August 7, 2018

**RE: *Los Altos 389 First Street – Traffic Assessment
Final Letter***

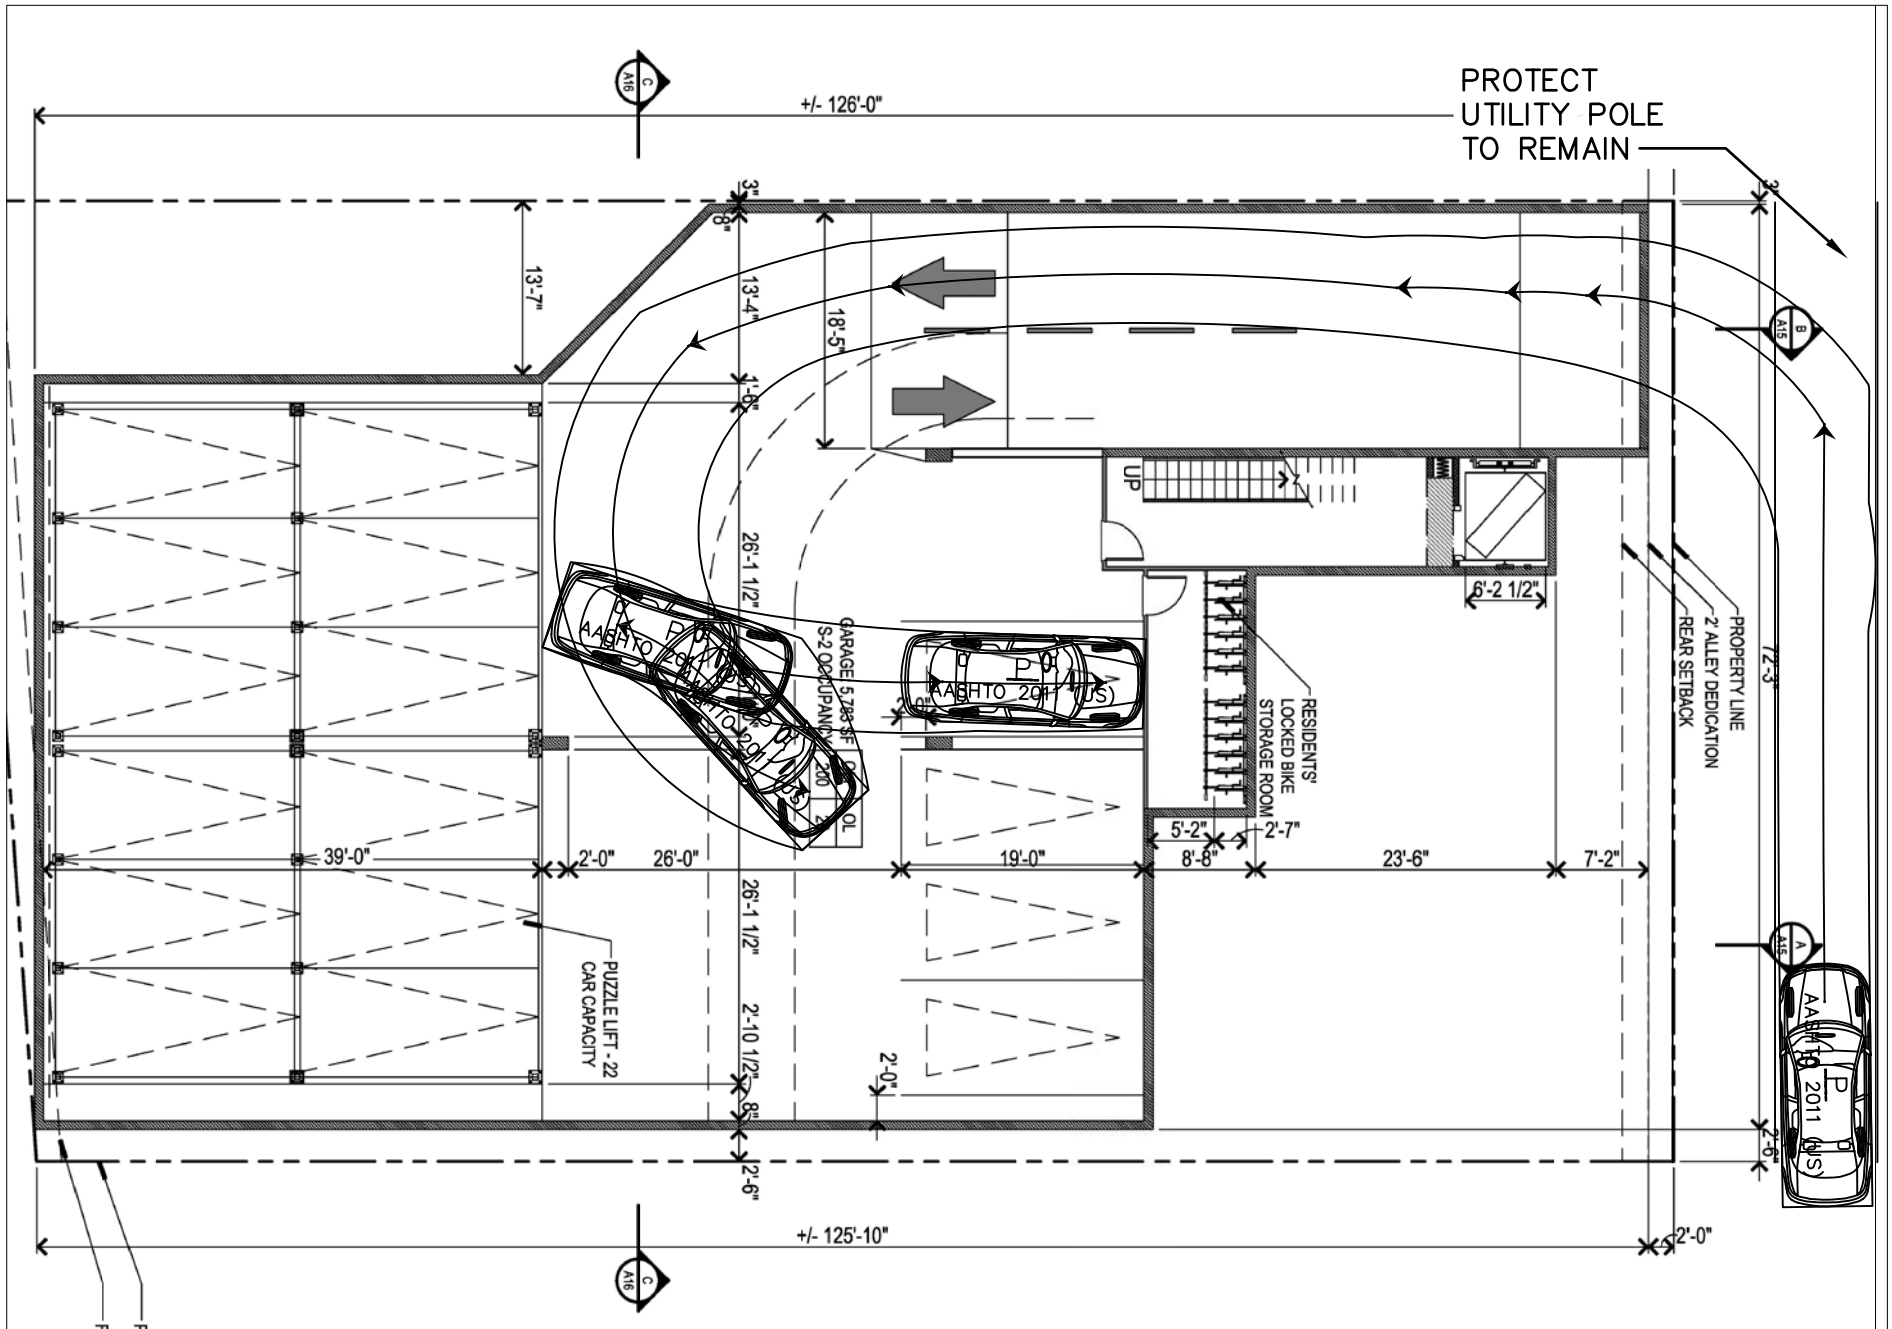
For motorists, there are four parking spaces on the ground level, of which two are accessible parking spaces. There are an additional 26 parking spaces on the garage level, with 22 parking spaces utilizing the puzzle lift parking system. Vehicles can access the parking garage via the alleyway on the east side of the project site and descend down the vehicle ramp. The vehicle ramp is 18.5 feet wide for two-way traffic, which exceeds the City's 18-foot requirement. A vehicle turning evaluation was completed to determine where potential maneuvering issues may arise. **Attachment A** shows the expected turning path of outbound vehicles and **Attachment B** shows the expected turning path of inbound vehicles. **Attachment C** shows the maneuvering to use the parking lift system. Potential issues may include:

- There may be conflicts for opposing vehicles on the alley since the existing alley is only 16 feet wide for two-way traffic. It should be noted that this is an existing condition and the City is in the process of adding a 2-foot dedication for both sides of the public alley. This would result in a future 20-foot alley adjacent to the project site.
- The existing narrow alley results in vehicles making the left turn and right turn into the vehicle ramp to cross into the opposing traffic lane on the vehicle ramp as shown in **Attachment A** and **Attachment B**. However, this conflict would be a limited occurrence due to the low number of vehicle trips expected to be generated by the site. It also does not appear that the existing utility pole in the alleyway across from the ramp would conflict with either of these

two movements. If the City does have a concern with vehicles potentially damaging the existing utility pole, a protective barrier can be added to protect the pole.
